**CITY OF ESSEX JUNCTION  
DEVELOPMENT REVIEW BOARD  
PUBLIC HEARING AGENDA**

**To:** Development Review Board  
**From:** Michael Giguere, City Planner  
**Date:** July 17<sup>th</sup>, 2025  
**Subject:** Site plan and conditional use review for the addition of a training center at the Champlain Valley Expo at 105 Pearl Street by the Essex Junction Fire Department.  
**File:** SP# 5.2025

**To:** Development Review Board  
**From:** Michael Giguere, City Planner  
**Date:** July 17<sup>th</sup>, 2025  
**Subject:** Design review for the construction of a new single-family home at 40 Maple Street by Ron Bushey, owner.  
**File:** SP# 6.2025

3 Bedroom Single family Home  
2 Story

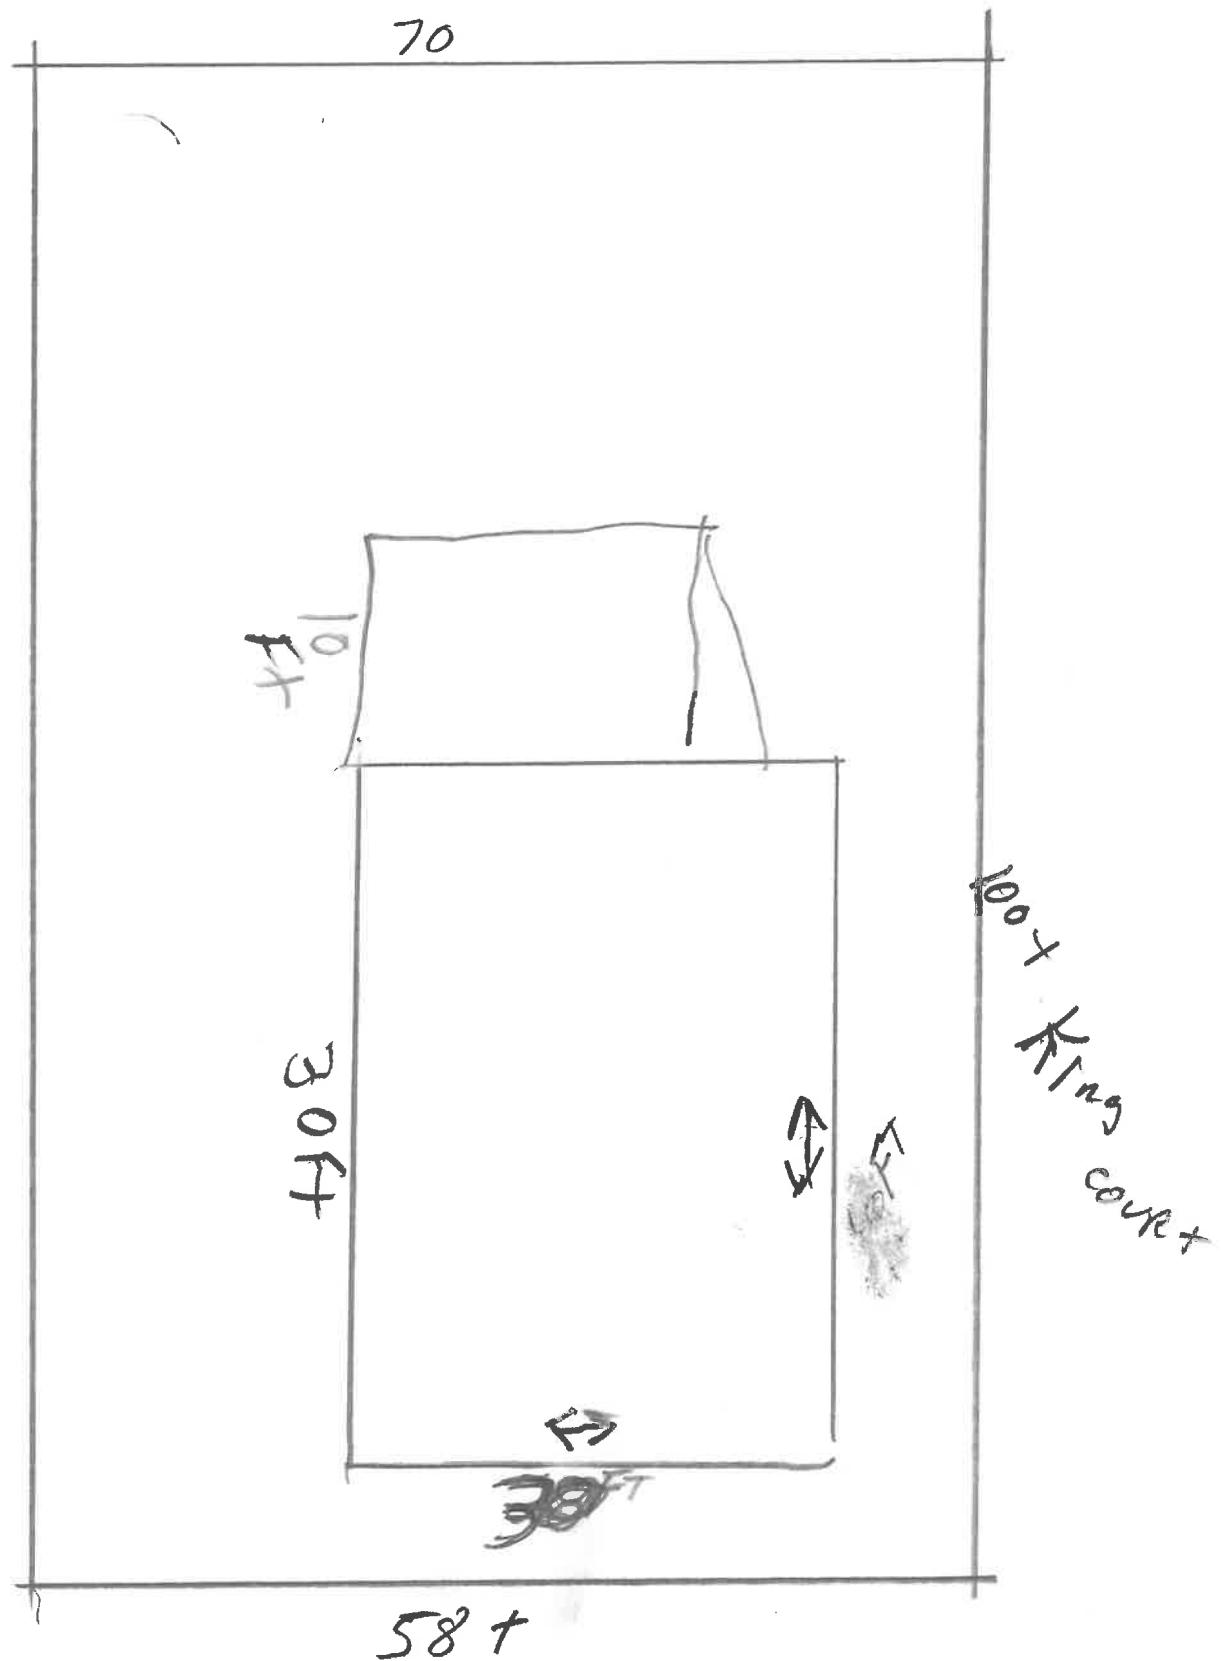
The applicant has provided pictures of existing landscaping and indicated the location of these materials on their site plan. No new landscaping additions are proposed.

FRONT ELEVATION  
SCALE: 1/4" = 1'-0"

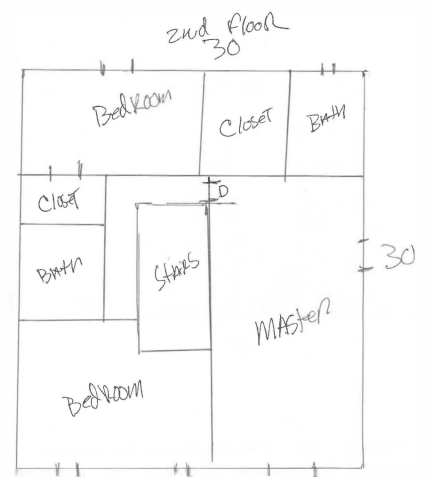
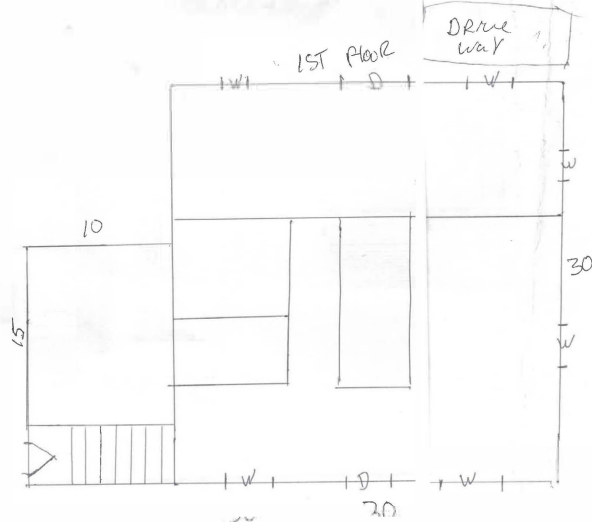
The application does not propose a street-facing pedestrian entrance. Staff have added this as a condition of approval.

Staff find that the proposed architectural elevations, while limited in detail, generally harmonize with the intention of Section 620 and include two required site features (direct pedestrian access and shade trees).

1. Applicant shall amend architectural elevations to include a street-facing pedestrian entrance to meet the requirements of Section 619.H.1.
